# DRCP IPP\_Activity

Version 1

Stephen Haddock

March 15, 2016

# DRCP\_State.IPP\_Activity:

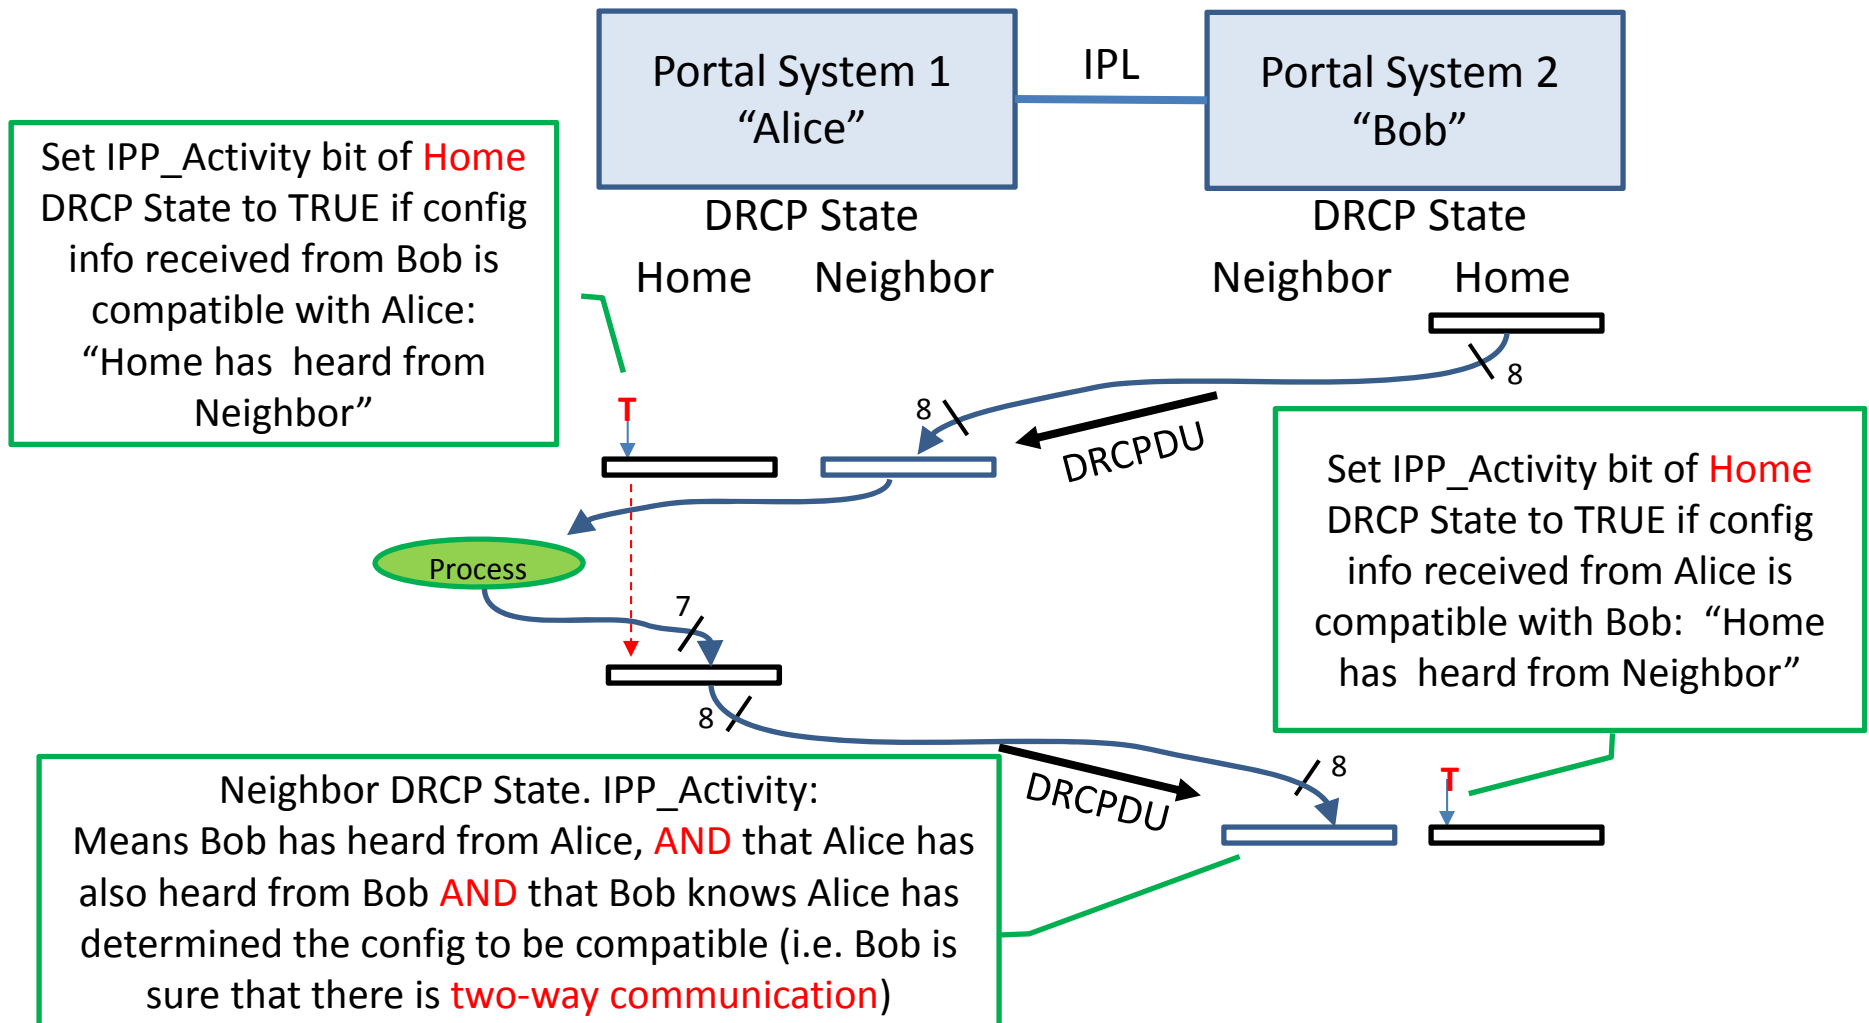
What comment requests:

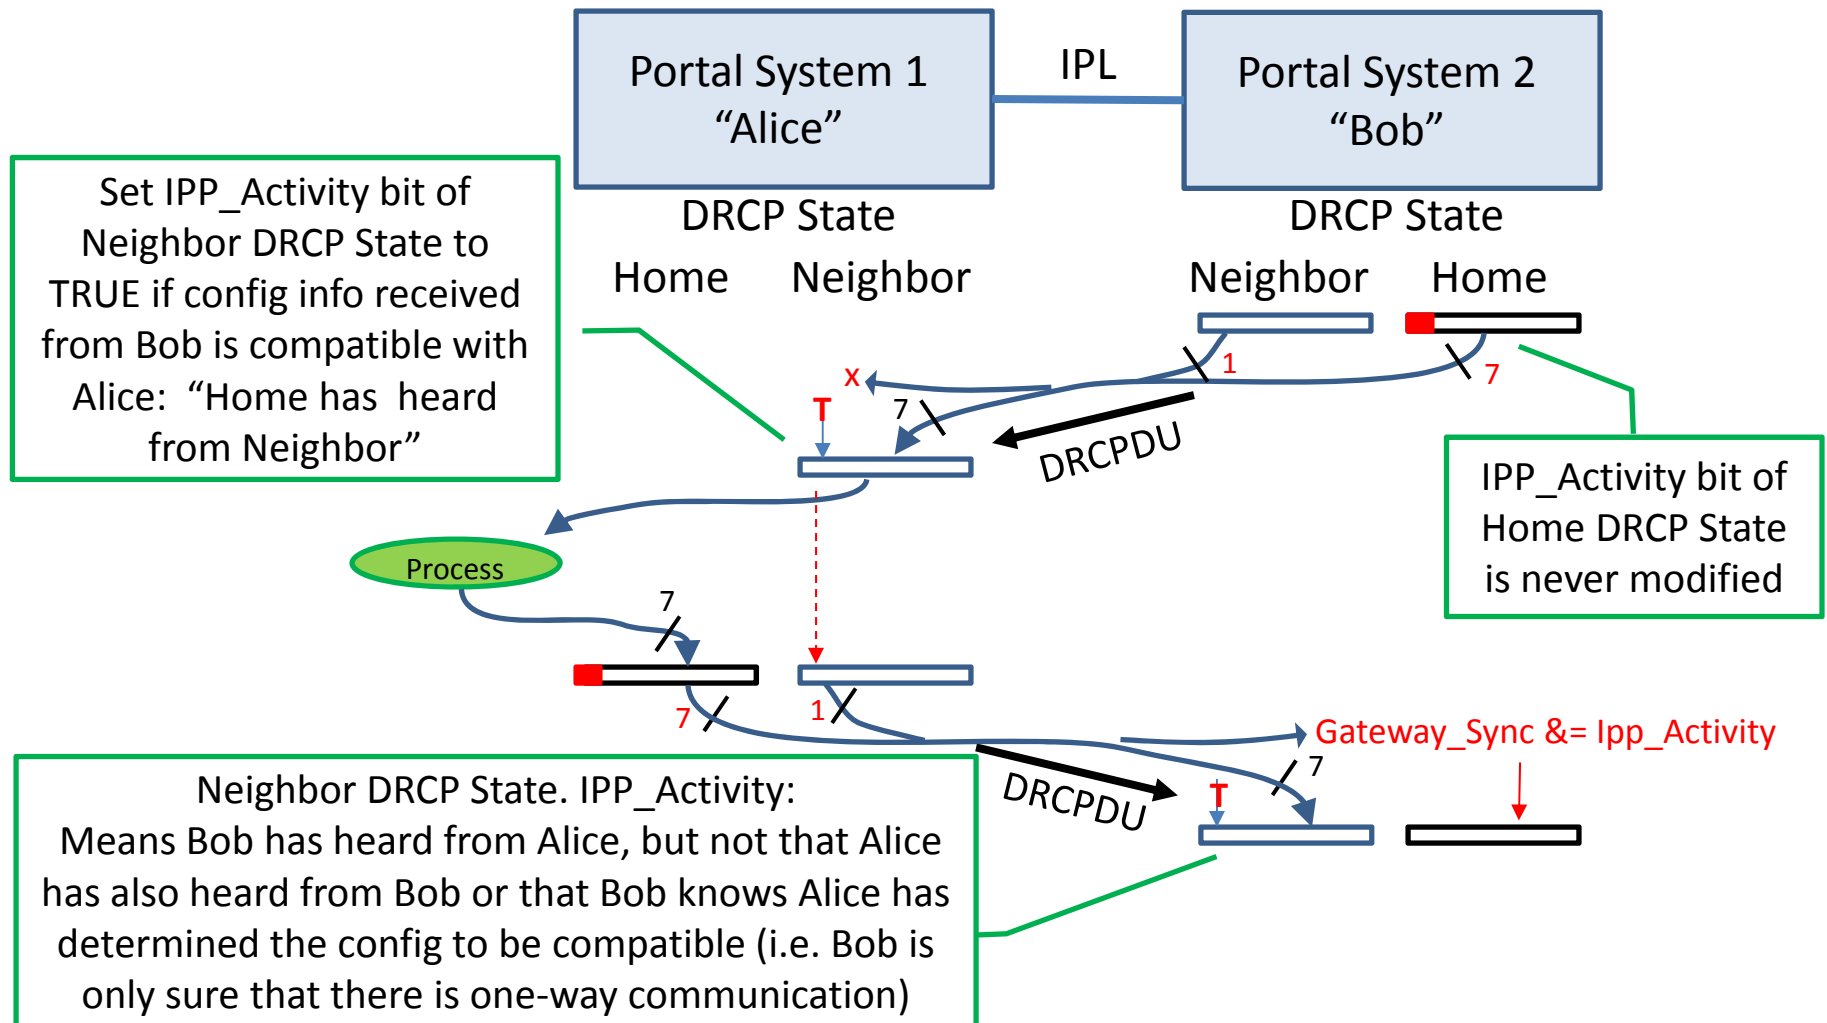
If the `IPP_Activity` variable in the transmitted DRCPDUs comes from the Neighbor DRCP state, how can we reference it as “the received `DRF_Home_Oper_DRCP_State.IPP_Activity`” ?
- “This function sets `DRF_Neighbor_Oper_DRCP_State.IPP_Activity` to TRUE and records the parameter values for the `Drni_Portal_System_State[]` and `DRF_Home_Oper_DRCP_State` carried in a received DRCPDU [item s) in 9.4.3.2] on the IPP, as the current parameter values for `Drni_Neighbor_State[]` and `DRF_Neighbor_Oper_DRCP_State` associated with this IPP respectively, with the exception of the `IPP_Activity` bit. In addition, if the received `DRF_Home_Oper_DRCP_State.IPP_Activity == FALSE` then `DRCPDU_DRF_Home_Oper_DRCP_State.Gateway_Sync = FALSE`”

- On the plus side:
  - The proposed response does fix the bug that the Neighbor DRCP State.IPP\_Activity is set TRUE and then immediately overwritten with the received DRCP State.IPP\_Activity which is always FALSE.
    - The comment resolved this by making it the Home DRCP State.IPP\_Activity is set TRUE and then the value received in the DRCPDU is stored in the Neighbor DRCP State.IPP\_Activity
- On the minus side:
  - The way the IPP\_Activity bit gets into the DRCPDU gets really screwy, but nothing fundamentally changes. Still only verify one-way communication.
- This resolution is not acceptable to the commenter

- The variable `DRF_Neighbor_Oper_DRCP_State.IPP_Activity` is important for the DRCPs state machine operations and should not be redefined. **The `IPP_Activity` variable in the transmitted DRCPDUs just references the `DRF_Neighbor_Oper_DRCP_State.IPP_Activity` value.** The `DRF_Neighbor_Oper_DRCP_State.IPP_Activity` is set or cleared to indicate DRCPDUs have been received from the Neighbor. All the other bits of the `DRF_Neighbor_Oper_DRCP_State` are copied from the received DRCPDU. This needs to be clarified in the `recordNeighborState` function.

- The current text: “This function sets `DRF_Neighbor_Oper_DRCP_State.IPP_Activity` to TRUE and records the parameter values for the `Drni_Portal_System_State[]` and `DRF_Home_Oper_DRCP_State` carried in a received DRCPDU [item s) in 9.4.3.2] on the IPP, as the current parameter values for `Drni_Neighbor_State[]` and `DRF_Neighbor_Oper_DRCP_State` associated with this IPP respectively, with the exception of the `IPP_Activity` bit. In addition, if the received `DRF_Home_Oper_DRCP_State.IPP_Activity == FALSE` then `DRCPDU_DRF_Home_Oper_DRCP_State.Gateway_Sync = FALSE`”
